Transport Assessment Addendum

Anglia Square, Norwich

Iceni Projects Limited on behalf of Weston Homes Plc

A8. ROAD SAFETY AUDIT AND DESIGNERS RESPONSE

DRAWN BY MG	CHECKED BY RJ	APPROVED BY CB
SCALE @ A1 1:250	DATE 08/10/2021	DATE 08/10/2021
PROJECT NO. 25-T123	DRAWING NO. 01	REV. A

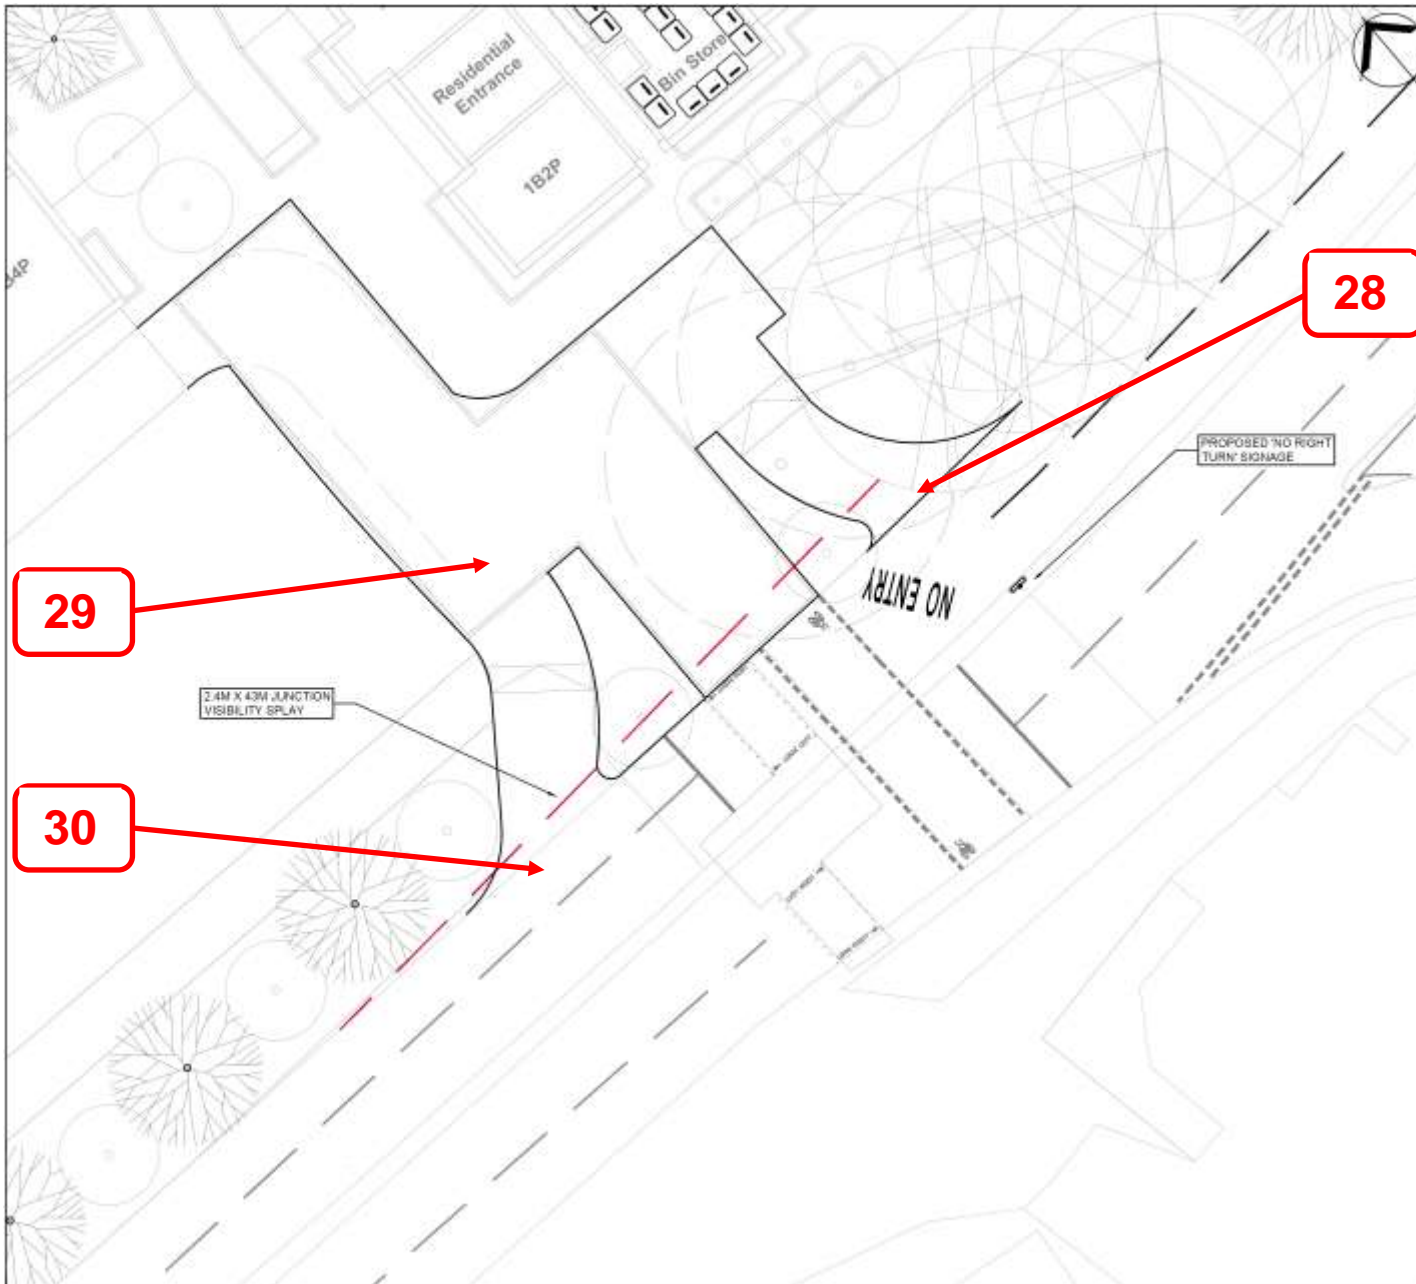
Location: 28 – St Crispins Road, proposed left out egress junction. (Drawing no. 21-T123-01 Rev A).

The scheme drawing indicates the existing diverge lane from St Crispins Road into the development site is to be removed and a left only egress provided on the eastern side of the signal controlled parallel crossing facility.

It is evident from the scheme drawing that the visibility splay would be impacted by pedestrians and pedal cyclists located on the northern side of the signal controlled parallel crossing facility when seeking to cross St Crispins Road. It would be reasonable to expect the development site would result in an increase in pedestrians and pedal cyclists using the signal controlled parallel crossing facility.

Location: 29 – Off St Crispins Road, proposed development site. (Drawing no. 21-T123-01 Rev A)

The scheme drawing indicates the existing diverge lane from St Crispins Road into the development site is to be removed and a left only egress provided on the eastern side of the signal controlled parallel crossing facility.

The site visit has established that at the end of the entry road into the development site, there is a give-way road marking, which has not been indicated on the scheme drawing.

Location: 30 – St Crispins Road, access junction. (Drawing no. 21-T123-01 Rev A)

The scheme drawing indicates the existing diverge lane from St Crispins Road into the development site is to be removed and a left only egress provided on the eastern side of the signal controlled parallel crossing facility.

RSA problem	RSA recommendation	Design organisation response	Overseeing Organisation response	Agreed RSA action
2.3.3.) St Crispins Road, proposed left out egress junction Restricted visibility at the egress junction could result in a potential increased risk of side impact type collisions occurring, whereby vehicle occupants could sustain personal injury.	It is recommended that the egress junction should be signalled in order to mitigate the above described potential collision scenario.	Not accepted – the visibility only marginally encroaches into the area where pedestrians / cyclists would wait. In practice, they do not stand adjacent to the kerb but fractionally back and therefore vehicles would be seen approaching. Further, should this visibility splay be instructed on rare occasions due to pedestrians waiting this would mean that the crossing would be

RSA problem	RSA recommendation	Design organisation response	Overseeing Organisation response	Agreed RSA action
2.3.4) Off St Crispins Road, proposed development site. Lack of priority within the proposed development site could result in a potential increased risk of vehicular collisions occurring, whereby vehicle occupants could sustain personal injury.	It is recommended that the existing give-way markings at this location should be retained.	Understood, however, the whole of the priority in this area is being changed as part of the proposals including new surface treatment, reduction in vehicle flows and pedestrian / cycle priority. As such, details will be shown at Stage 2 as required.
